MEMORANDUM

From:	Built Heritage Officer	Service:	Green Infrastructure
Application No.	251543 + 251544	Site Visit Made:	Previously.
Address:	Sussex Lodge, Sussex Lane, Spencers Wood, RG7 1BY.		
Proposal:	251543: Application for submission of details to comply with the following condition of planning consent 250179 dated 26/1/2025. Condition 3 relates to Windows and Doors, Condition 4 to Outbuilding Brickwork, Condition 5 to Insulation Measures, Condition 6 to Flinch Plates and Condition 7 to Chimney Breast. 251544: Application for submission of details to comply with the following condition of listed building consent 250178 dated 01/04/2025. Condition 3. Joinery Details. 4. Methodology Statement. 5. Insulation Details. 6. Flinch Plate Details. 7. Chimney Breast Details.		
Relevant built heritage condition text.	3. Notwithstanding the details submitted, no works relating to internal and external windows or doors shall take place until full joinery details to install the hereby permitted replacement windows and doors have been submitted to and approved in writing by the local planning authority within 3 months of the date of this decision. Details are to include: • Documentation, in

Extract of SL108D - note missing small square window adjacent to exterior kitchen door.

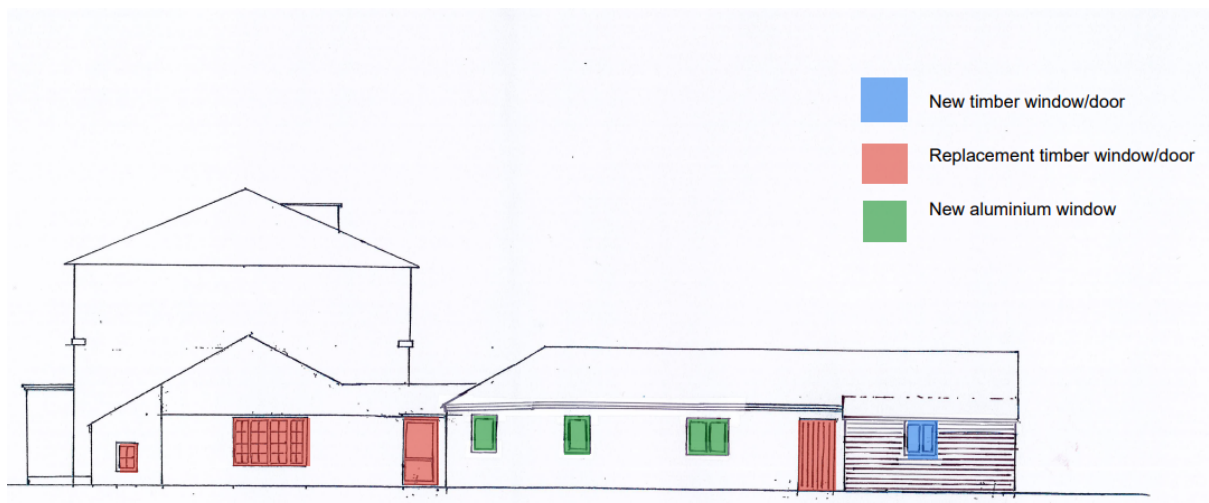
The annotated elevation drawings (SL107E and SL08D) submitted under this application to discharge the windows and exterior doors condition identifies 3 no. small square windows to the store on the side of the former kitchen are to be replaced along with the large four light multipane window on the NW facing elevation of the former kitchen.

It is believed the replacement of these windows for which I do not recall any indication were to be replaced in the previous approved applications or even the most recent ones. As such, the no assessment previously of the significance of these windows

or justification for their replacement has been provided and neither have the windows being studied at the time of visiting the site either. It is therefore believed the replacement of these windows had not formed part of the works for which consent was given for.

It should also be pointed out, in checking up about whether the windows had been part of the consented works has resulted in it being noted a small square window on the NW facing elevation of the former kitchen has been consistently missed off the existing /proposed plans on all the applicant's pre-application and application submissions.

Given the applicant seeks to replace the windows of the former kitchen and store it seems likely then that the applicant would also be seeking to replace this omitted window to.

The existing 3no. small square windows to the store and that one on the NW facing elevation of former kitchen are from photographic evidence original. Unfortunately there is no clear photographic images of the large kitchen window, which evidently maybe modern and uPVC.

There appears to be no specific joinery detail provided for any of these windows and whilst the 3no. existing square windows are side hung opening windows. Potentially then the Timber Window's Cottage Casement (Ovolo) 18mm units could be acceptable, for the small square windows however this design is not thought appropriate or possible for the larger 4 lite mullioned window of the former kitchen.

The replacement of these windows would appear to be require the need for a new application to be made and consent given to do so.
